Attachment J3

Submissions

Planning Submission
For: SP 67057: 23 Billyard Avenue, Elizabeth Bay

Development Application ('DA') No. 2023/0727
'Demolition of existing buildings, tree removal, excavation and construction of two new residential flat buildings, 6 to 8 storeys in height, with 22 apartments, 4 basement levels containing 27 car spaces, rooftop terraces, swimming pools and associated landscaping works including new tree plantings. The application is Integrated Development requiring the approval of Water NSW under the Water Management Act, 2000.'

12.00pm Existing

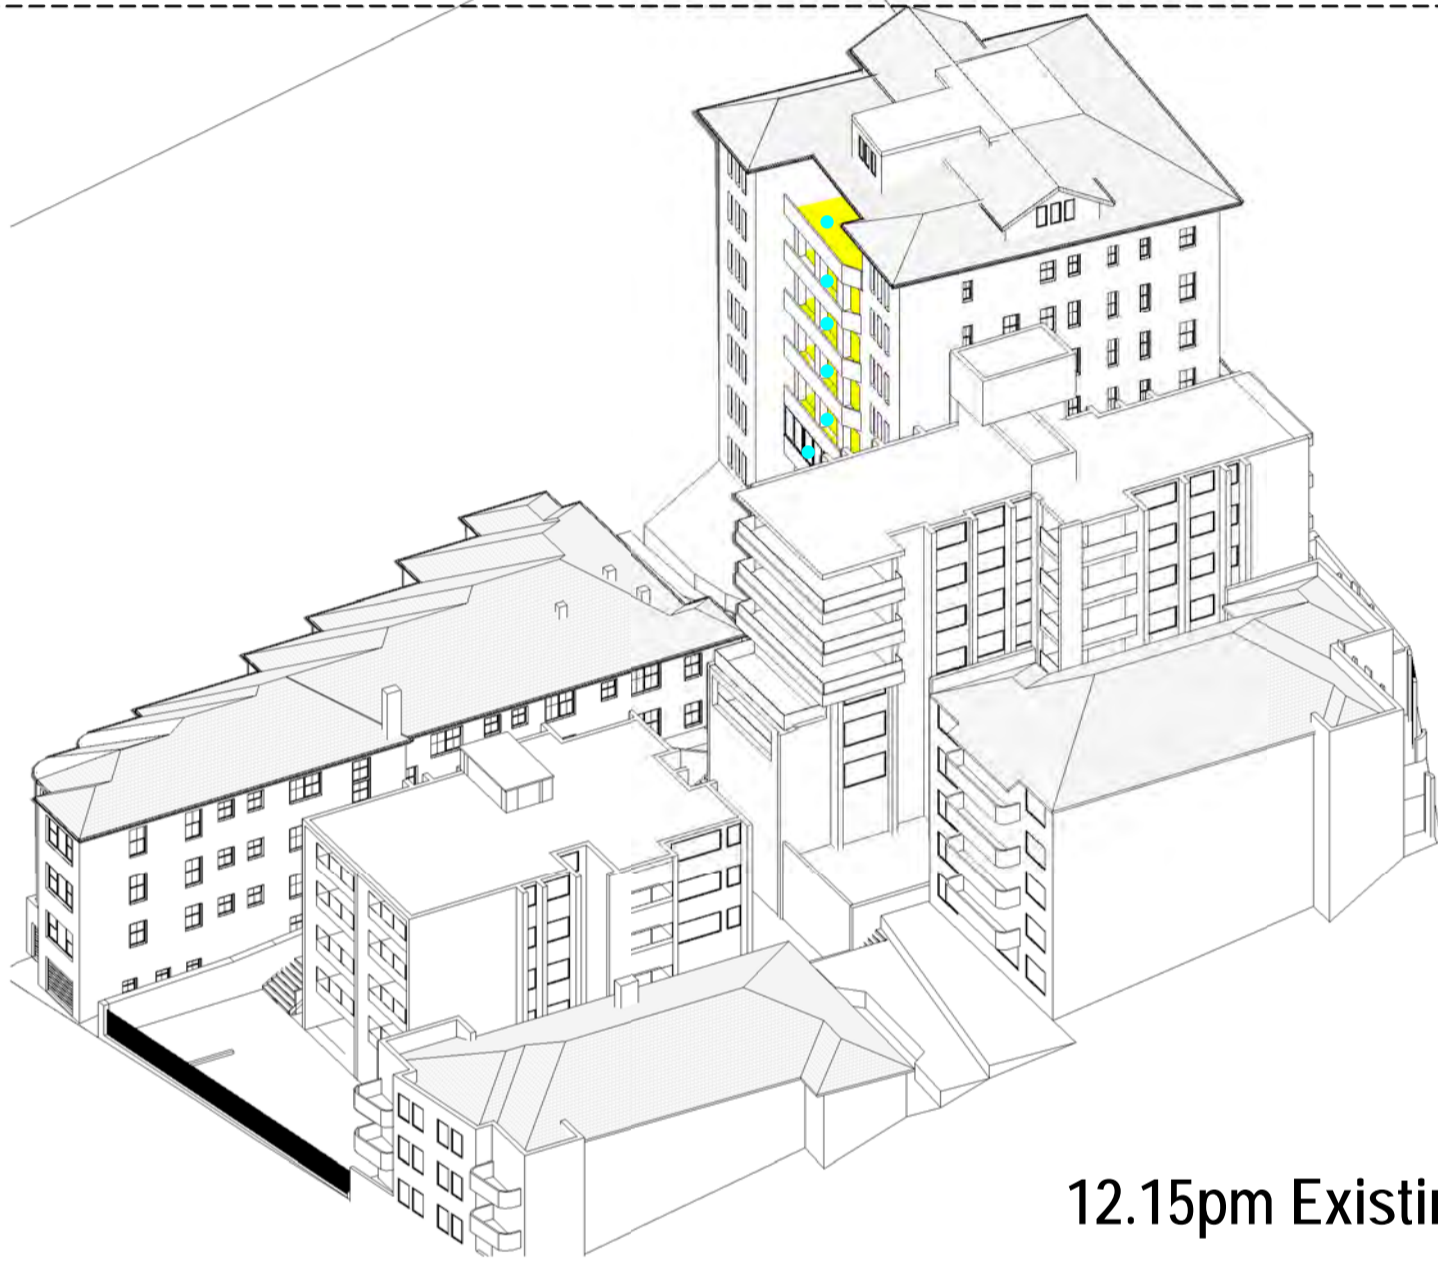
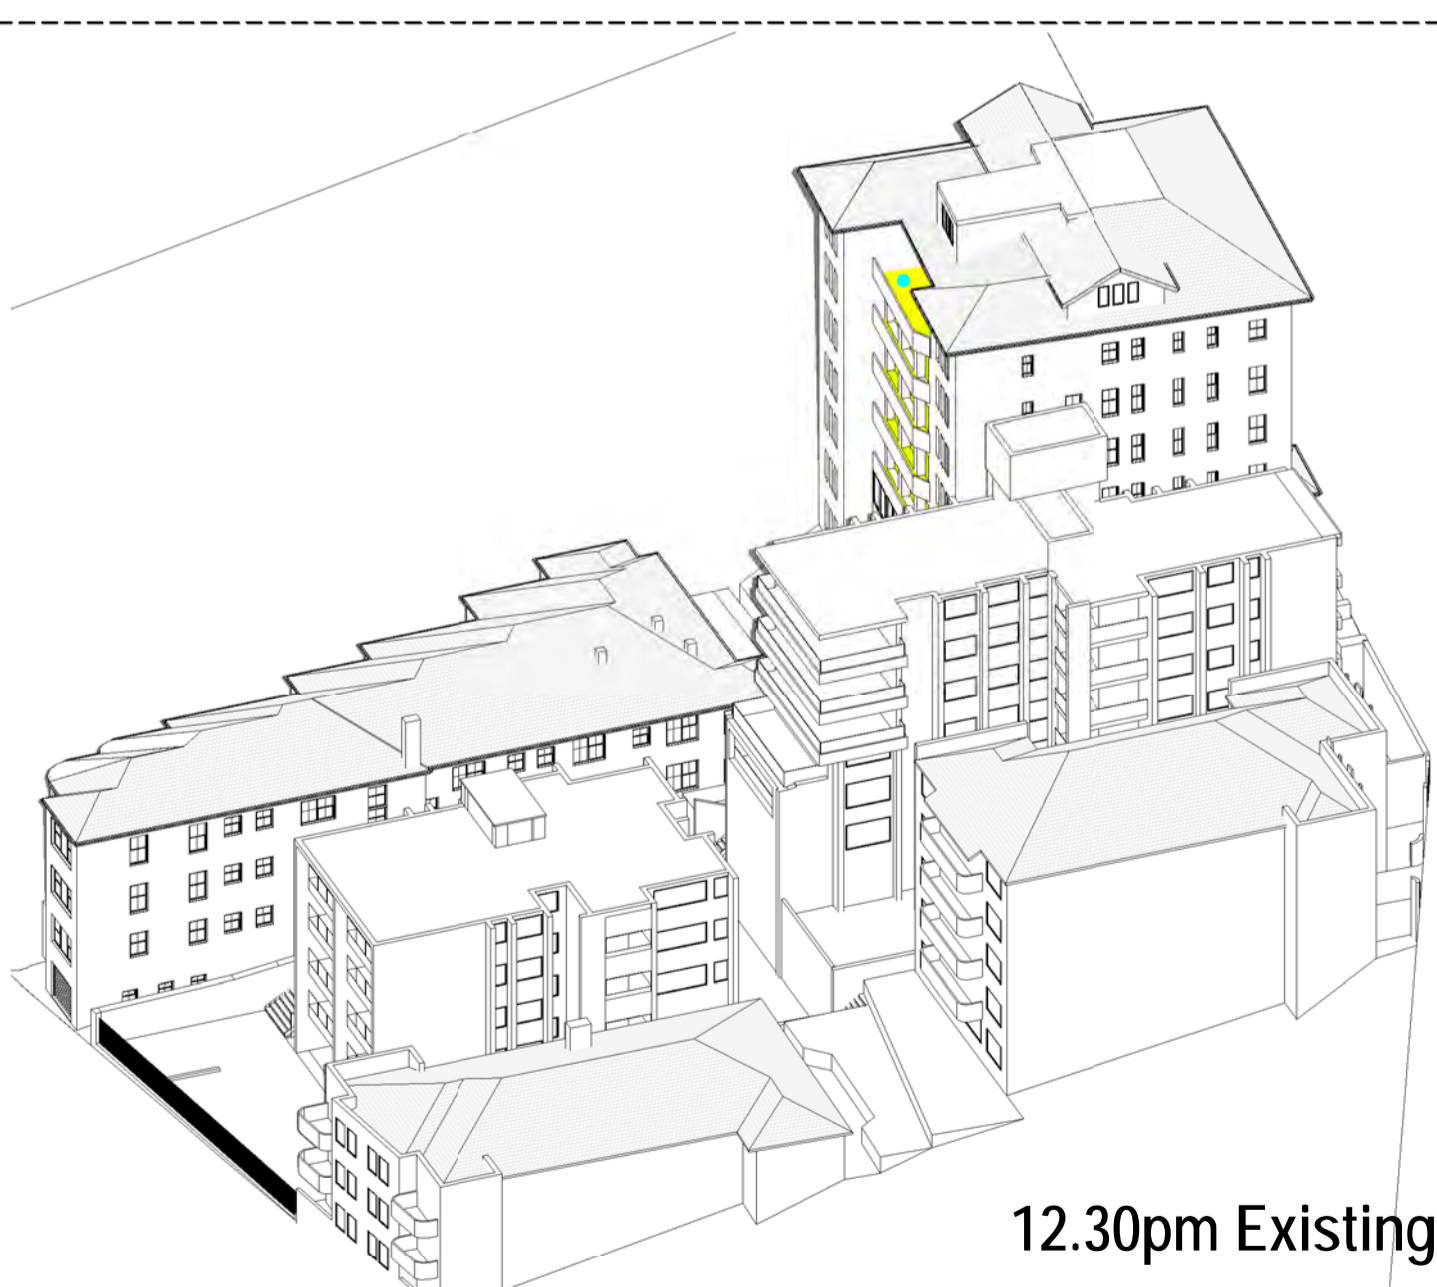
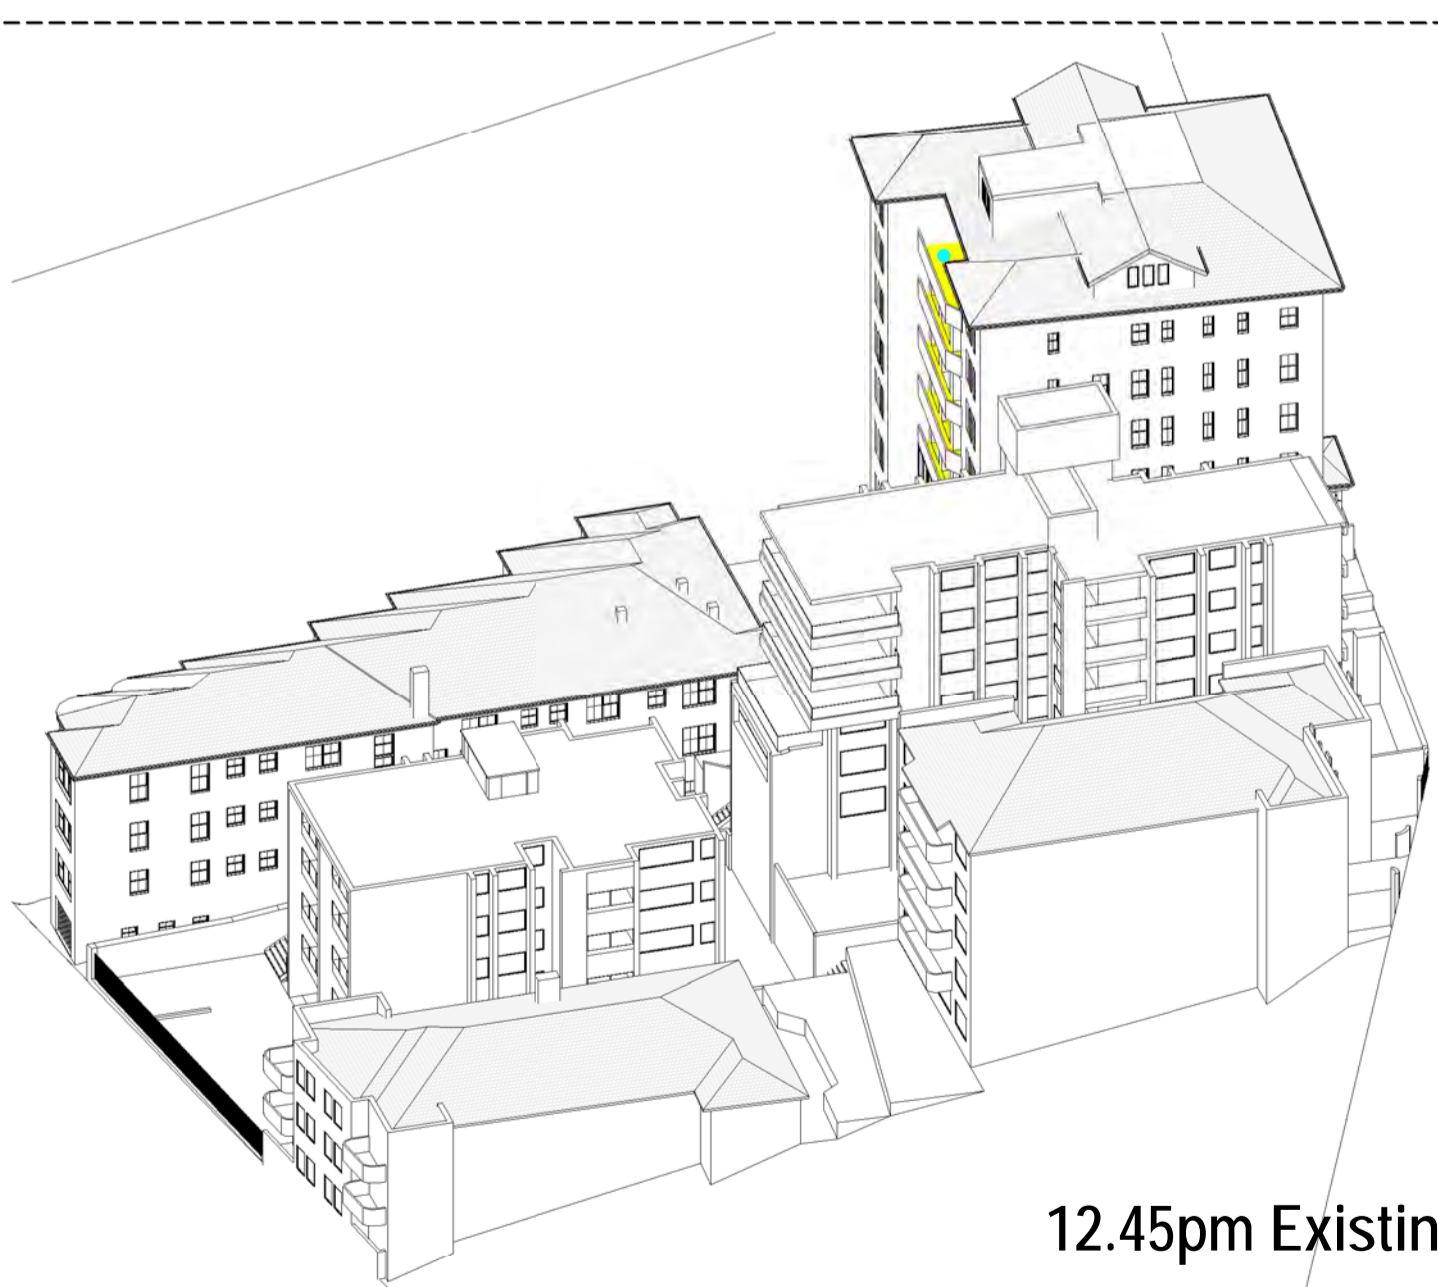
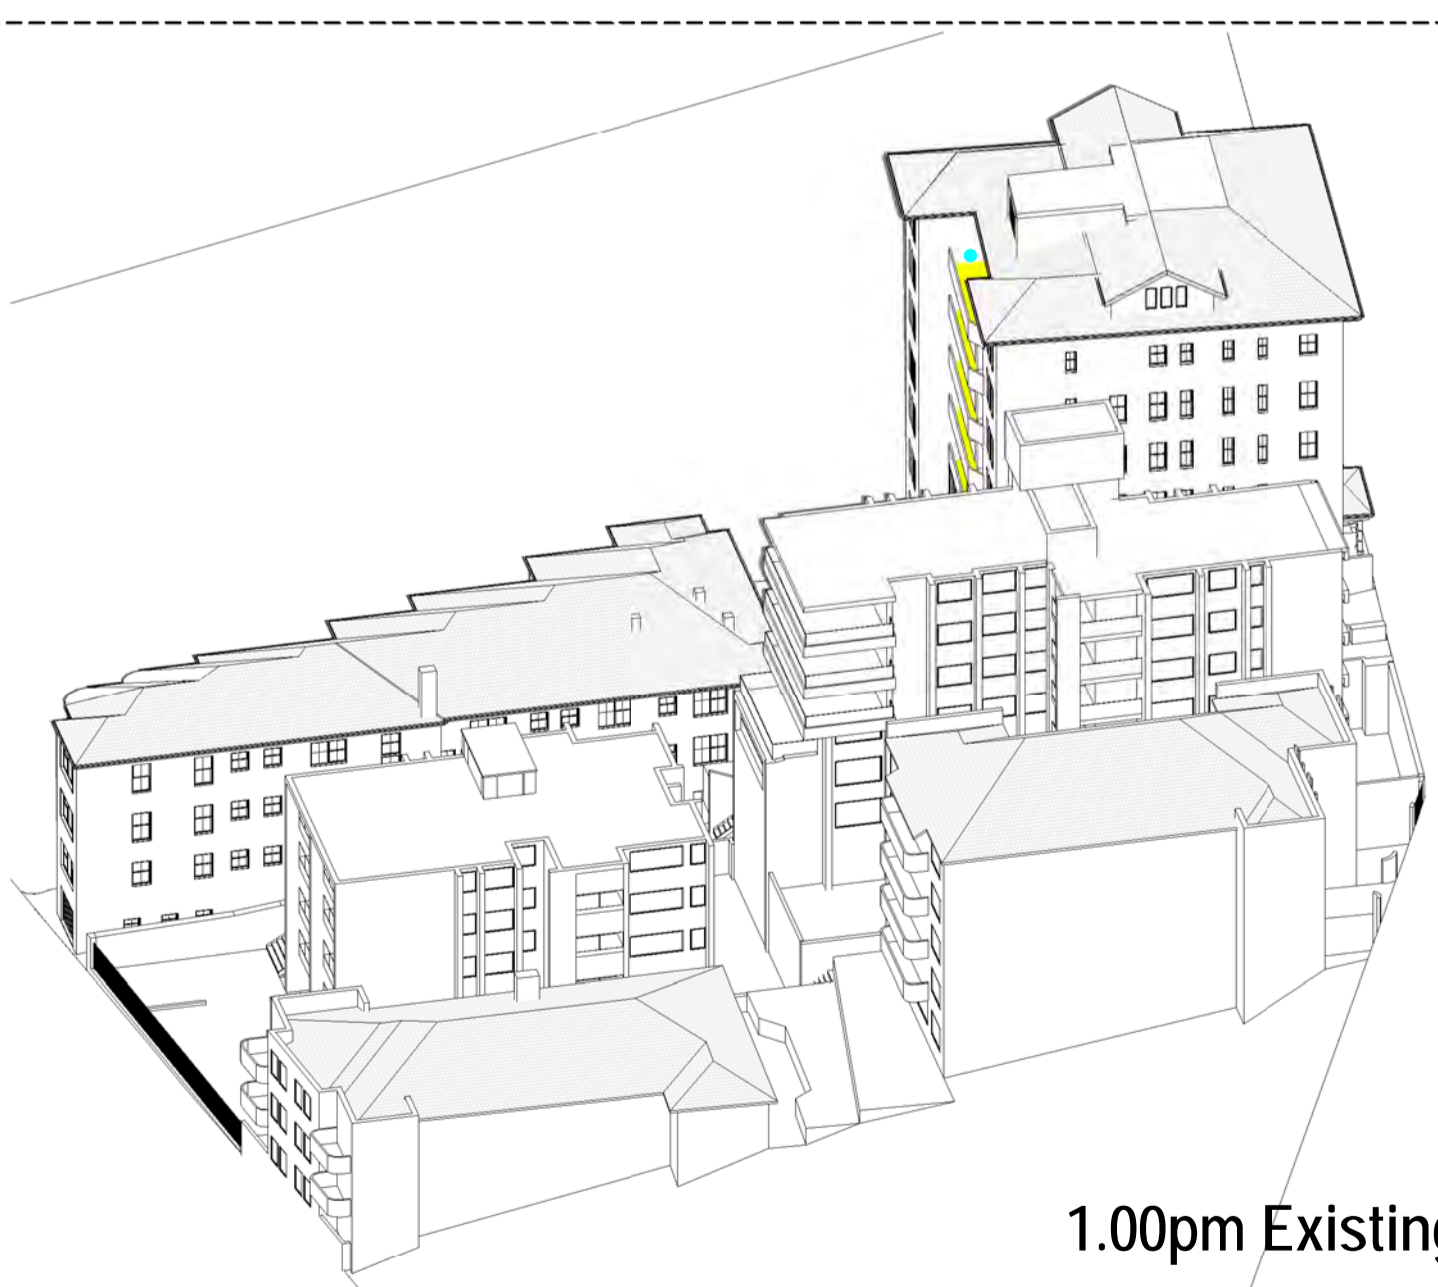
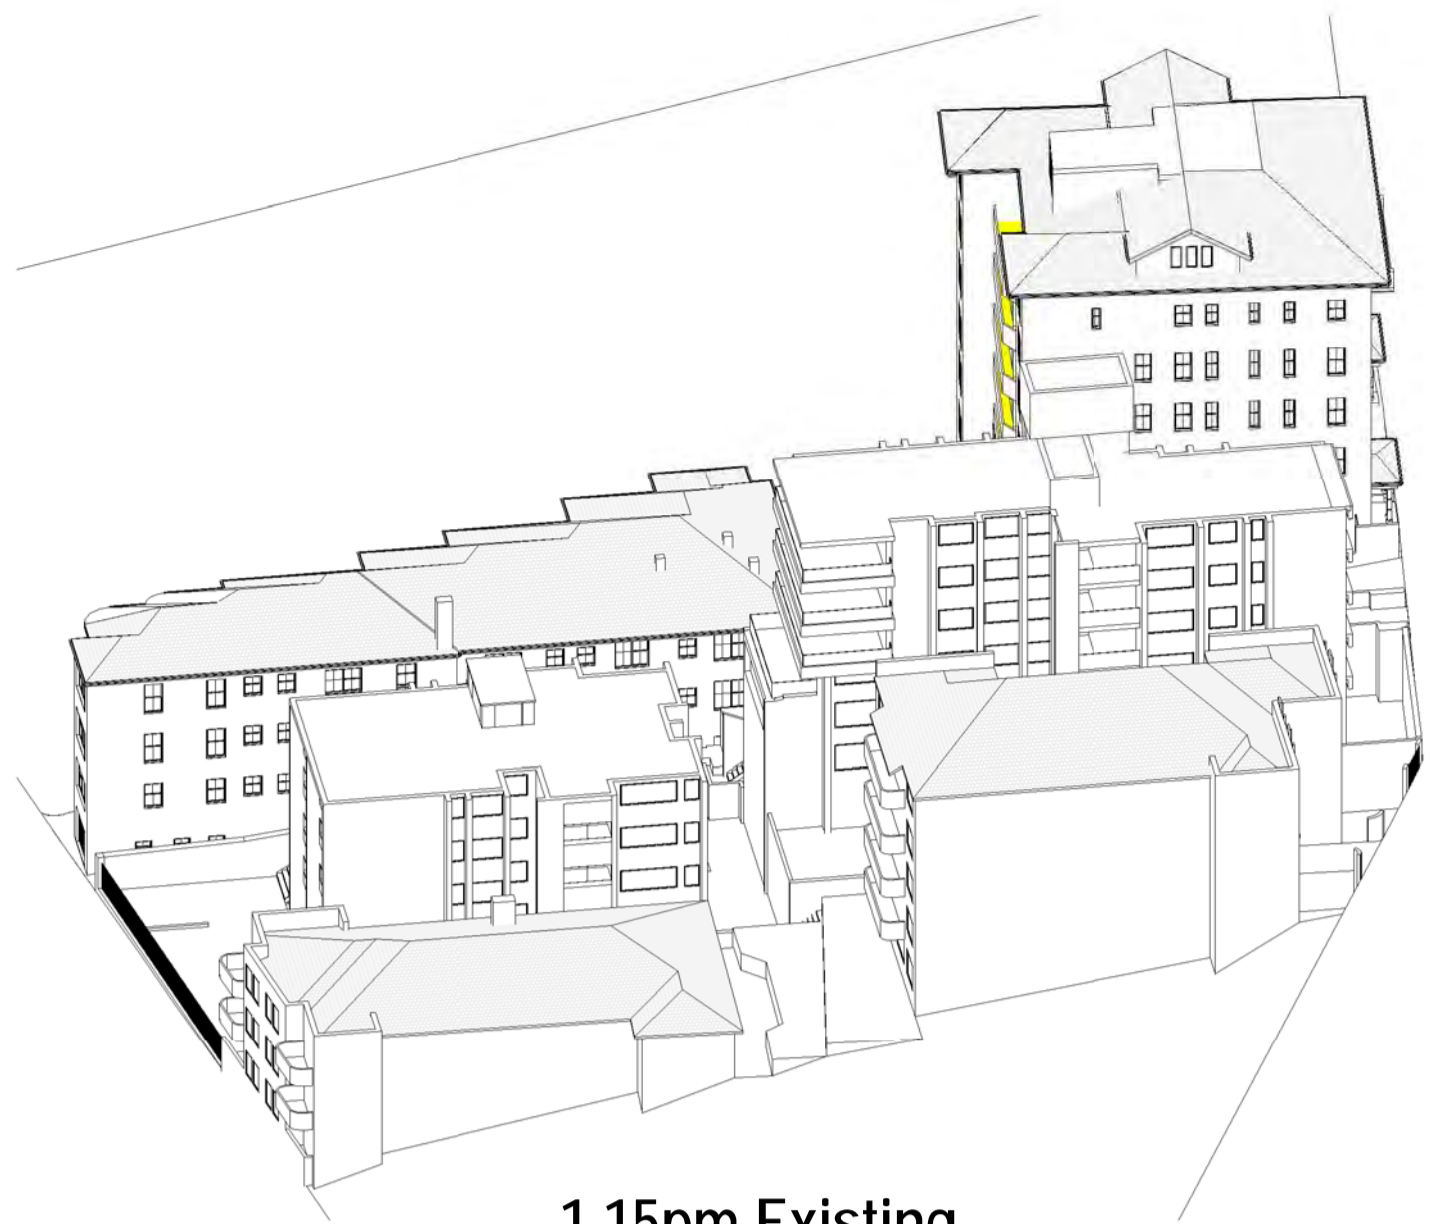
The solar diagrams show worsening of solar access to these only areas of living space (no balconies available). It is noted that staff requested 15 minute intervals and these have not been provided for 23 Billyard Avenue.

9.00AM - 3.00PM				
	EXISTING:	PROPOSED:	ACCESS LOST:	% LOST:
P.O.S.				
LG2 UNIT 1	3.25 HOURS	1.75 HOURS	- 1 HOUR	44%
LG1 UNIT 3	3.25 HOURS	1.75 HOURS	- 1 HOUR	44%
GF UNIT 5	3.25 HOURS	1.75 HOURS	- 1 HOUR	44%
1 UNIT 7	3.25 HOURS	2.25 HOURS	- 0.75 HOUR	33%
2 UNIT 9	3.25 HOURS	3.25 HOURS	0	
3 UNIT 11	3.25 HOURS	3.25 HOURS	0	
4 UNIT 12	4 HOURS	4 HOURS	0
